Some 2019 – 2022 model year RAV4 and RAV4 Hybrid, and 2021 – 2022 model year RAV4 Prime vehicles may exhibit a sloshing or splashing noise from inside one or more door panels when driving, opening and/or closing a door, and/or braking. This condition is caused by a cavity wax/debris/substance that may block door drain holes and restrict water from draining properly. Follow the Repair Procedure in this bulletin to address this condition.

**TOYOTA** T-SB-0084-21 September 27, 2021 Page 2 of 11

# Sloshing or Splashing Noise From Inside One or More Door Panels

Figure 8. Weatherstrip Moulding

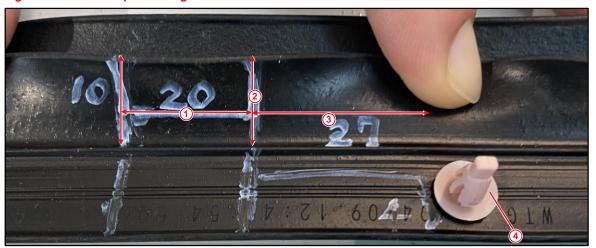
- 5. BEFORE reinstalling the front door weatherstrip mouldings trim the inner lip of the weatherstrip mouldings for ALL front doors to prevent debris build up in the future.
  - A. Measure 27 mm from clip No. 4 from the rear edge of the molding (right).

B. Cut the inner lip of the weatherstrip moulding with the following dimensions:

Length: 20 mm Height: 10 mm

1	Length of Cut: 20 mm
2	Height of Cut: 10 mm
3	Length Between Cut and Clip No. 4: 27 mm
4	Clip No. 4 (from rear edge of the molding)

Figure 11. Weatherstrip Moulding

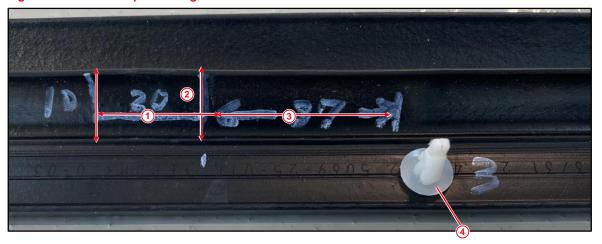
- 6. BEFORE reinstalling the rear door weatherstrip mouldings, trim the inner lip of the weatherstrip mouldings for ALL rear doors to prevent debris build up in the future.
  - A. Measure 37 mm from clip No. 3 from the front edge of the molding (left).

B. Cut the inner lip of the weatherstrip moulding with the following dimensions:

Length: 20 mm Height: 10 mm

1 Length of Cut: 20 mm
2 Height of Cut: 10 mm
3 Length Between Cut and Clip No. 3: 37 mm
4 Clip No. 4
